**RE: FINAL DETERMINATION, CLASS 2 MODIFICATION REQUESTS**  
**WIPP HAZARDOUS WASTE FACILITY PERMIT**  
**EPA I.D. NUMBER NM4890139088**

The New Mexico Environment Department (NMED) hereby approves certain Class 2 permit modification requests (PMRs) to the WIPP Hazardous Waste Facility Permit as submitted to the Hazardous Waste Bureau (HWB) in the following documents:

Attachment 1 – Basis for Denial of Specific Class 2 Modifications  
Attachment 2 – redline/strikeout pages

Figure B1-1  
Headspace Gas Drum Age Criteria Sampling Scenario Selection Process

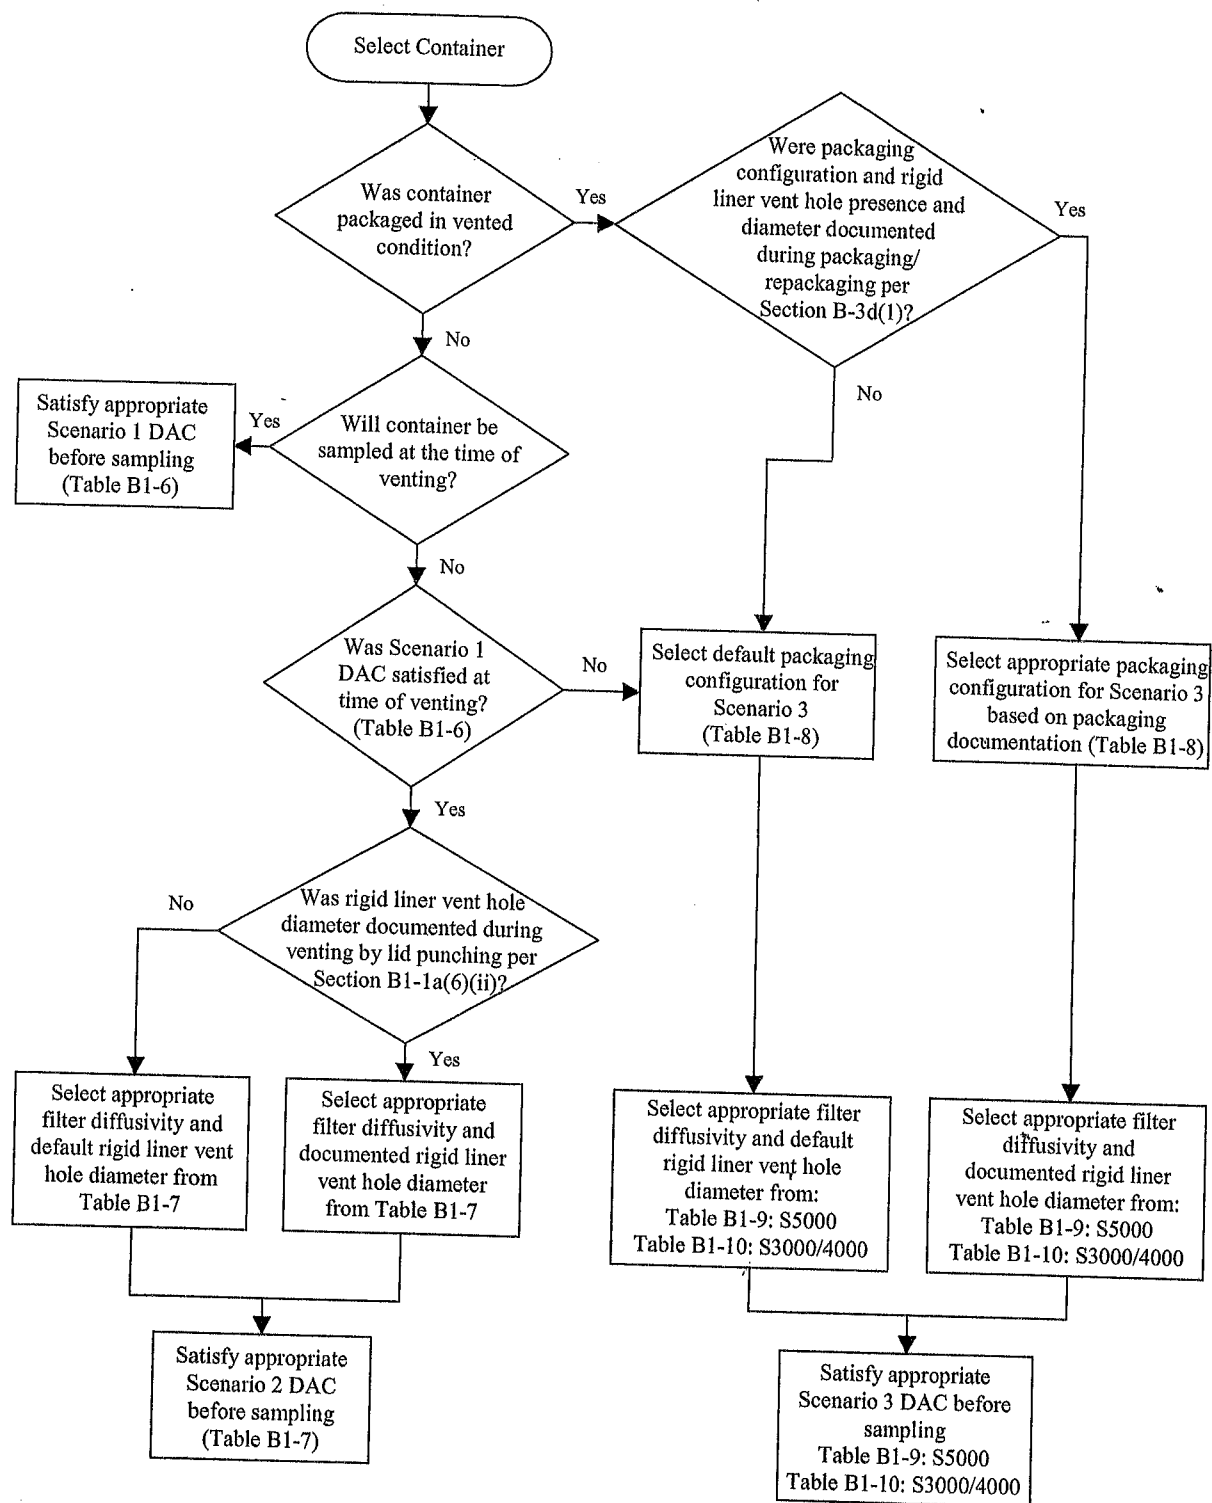
NMED identified numerous technical issues with the drum age criteria (DAC) modification as submitted, but some of these issues were addressed by the Permittees' comments. However, the PMR was not approved because the Permittees failed to provide all technical information necessary to make a complete analysis. These issues are as follows:

1. The Permittees' assignment of the 55-gallon drum DAC value to 85 and 100-gallon drums for a given packaging configuration is not supported by information provided in the PMR. The Permittees did not account for the differences in the rigid poly liner surface area in the 85 and 100-gallon drums in their assumptions. The time necessary for the rigid poly liner within a container to reach equilibrium is a significant portion of the time needed to reach steady state equilibrium in a waste container. The Permittees did not indicate whether the rigid poly liner surface area is fixed or scalable based upon the container size. However, the Permittees' discussion of the irrelevance of void volume scalability implies that the rigid poly liner volume or surface area is not fixed, and hence should be considered in DAC calculations. The Permittees should instead prepare separate DAC tables for 55-gallon drums, 85-gallon drums, and 100-gallon drums.

2. NMED believes that there several technical issues with respect to DACs for compacted waste that still need to be addressed to ensure that the proposed DAC approach and values within the PMR with respect to compacted waste are adequate. These issues are:
